RE: 1241 HARWOOD STREET
Development Application Number DE415100

Your application was considered by the Development Permit Board at its meeting of April 4, 2011, and it was resolved THAT the Board APPROVE Development Application No. DE415100 as submitted, the plans and information forming a part thereof, subject to City Council approval of a Housing Agreement, thereby permitting the development of a new 17 storey Multiple Dwelling (containing 36 dwelling units) over one level of underground parking having vehicular access from Harwood Street and two detached parking garages having access from the rear lane, subject to the following conditions:

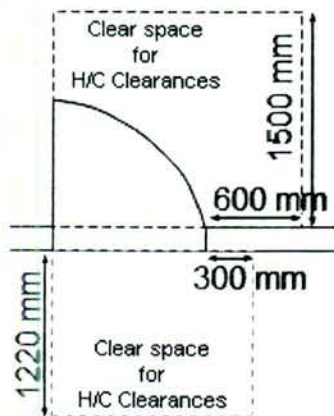
1. An accepted Alternative Solution for the Roof Covering Class rating is required for green roofs.
2. The following diagram shall be used for handicap clearances for doors into bicycle rooms, corridor doors on Level 2 to access the storage rooms, office on Level 3, etc.
